Central Planning Authority

Minutes of a meeting of the Central Planning Authority held on **28 February 2024 at 10:00am** in Conference Room 1038, 1st Floor, Government Administration Building, 133 Elgin Avenue

CPA/07/24

Figure 3. The application site with the parcel boundary highlighted in red and 2018 vegetation data with an overlay of the submitted plans (Architectural Plans Source: TAG Ltd, 2023).

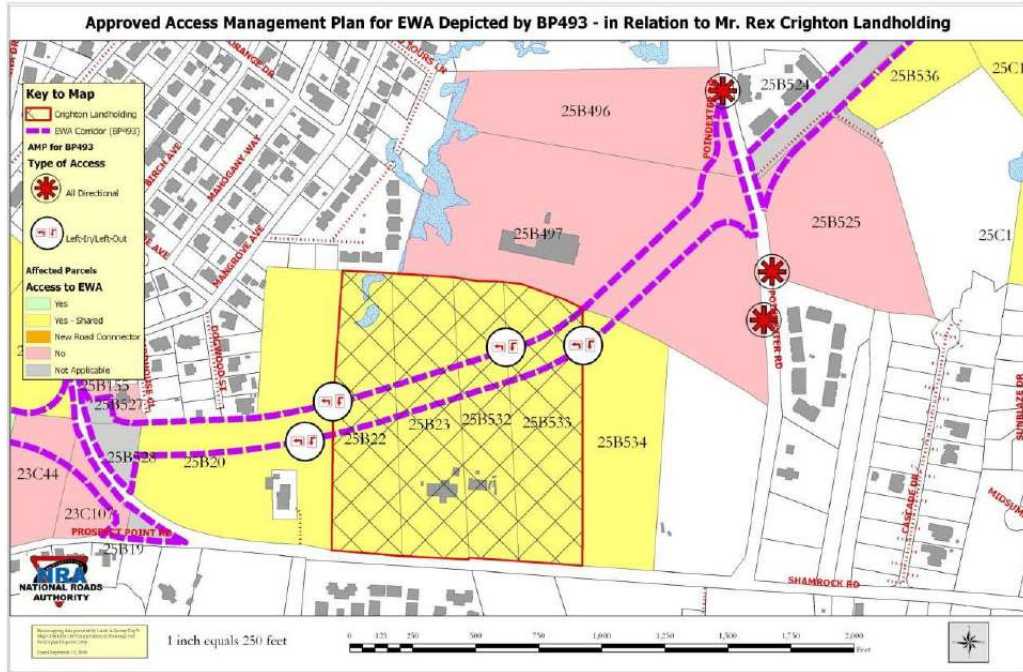
rainfall. They are climate-appropriate and require less maintenance and irrigation. Landscaping with native vegetation also provides habitat and food for native fauna such as birds and butterflies, promoting biodiversity and providing valuable ecosystem services. In particular, we strongly encourage the applicant to retain the wetland vegetation in the low-lying areas seen in Figure 3 below and utilise them for catchment.

Figure 1: Land cover over the subject parcel (outlined in pink) (Source: DoE, 2018).

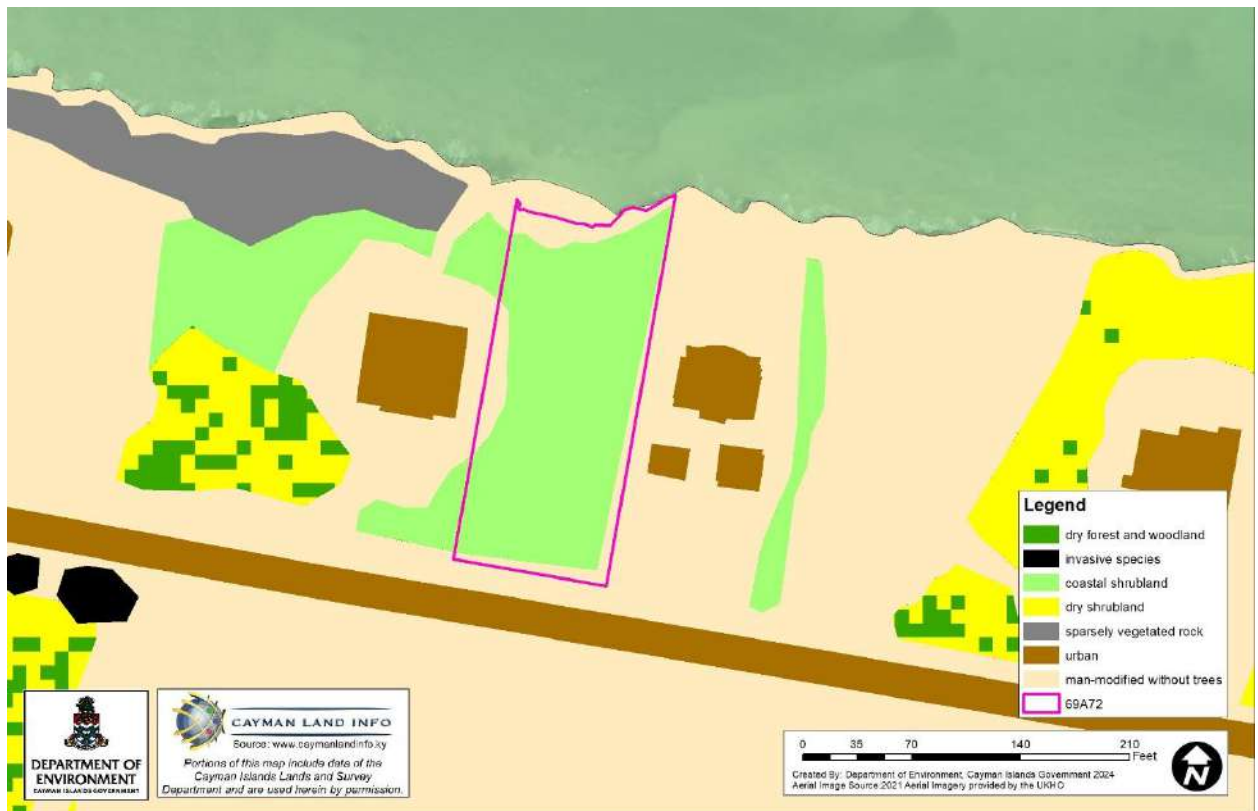
The site is largely primary habitat consisting of coastal shrubland, with some man-modified habitat at the property boundaries (refer to figure 1).

Figure 2: Site layout showing the proposed development footprint as per the applicants plans (Aerial Imagery Source: UKHO, 2021).

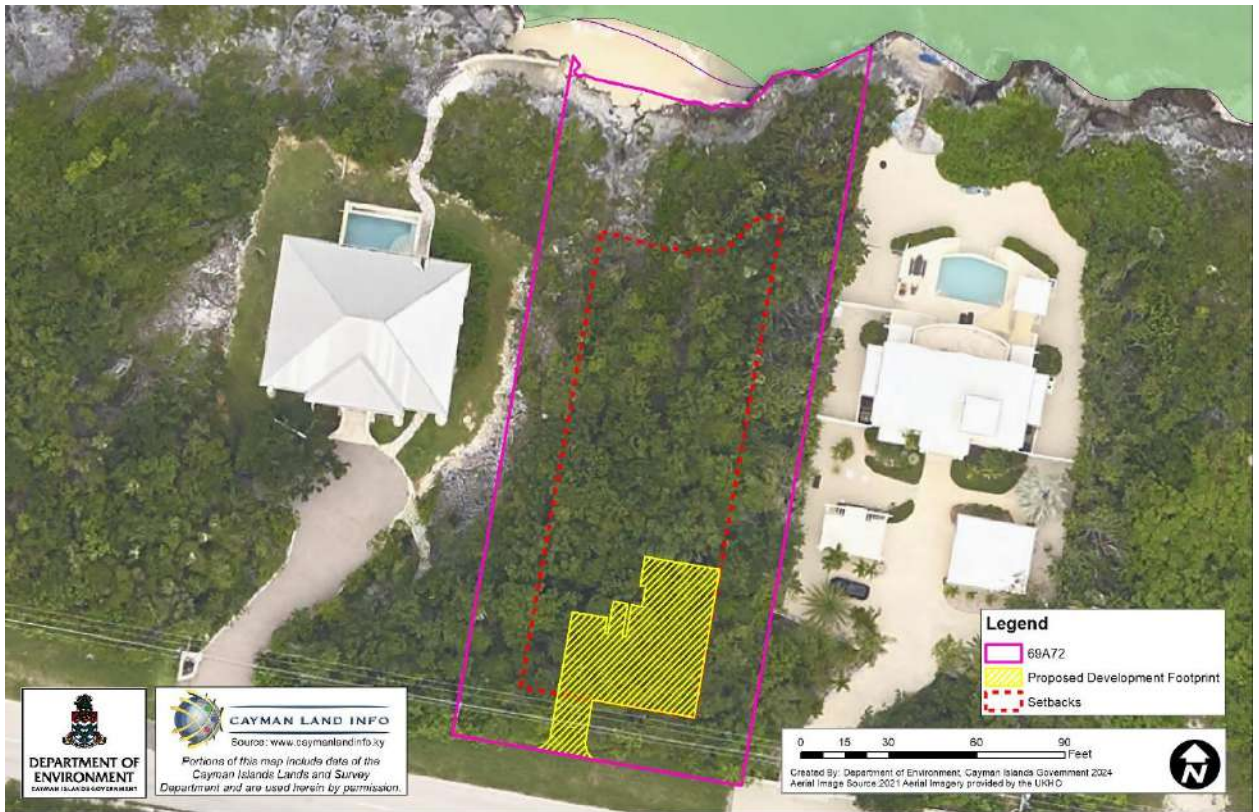
The DoE notes that the proposed development has been sited sensitively with respect to coastal setbacks (refer to figure 2). This is important for maximizing the resiliency of coastal development with respect to the effects of climate change including increased intensity of storms and sea level rise predictions for the area. The site layout provides opportunity to retain native vegetation on the site.

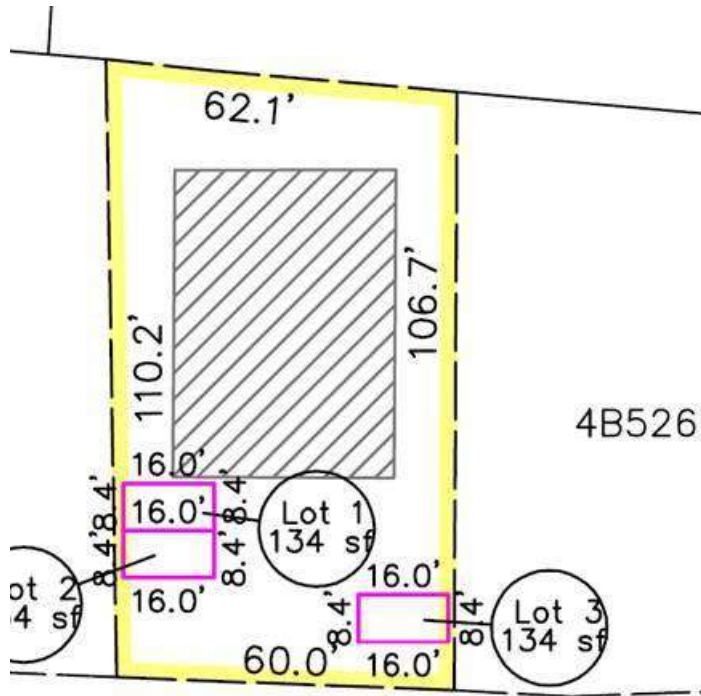
The current application (P23-1162) seeks permission for 3 raw land strata lots in the parking area:

Proposed lots 1-3 directly correlate with parking spaces established under P20-1063, the remaining 2 parking spaces would form visitor parking.
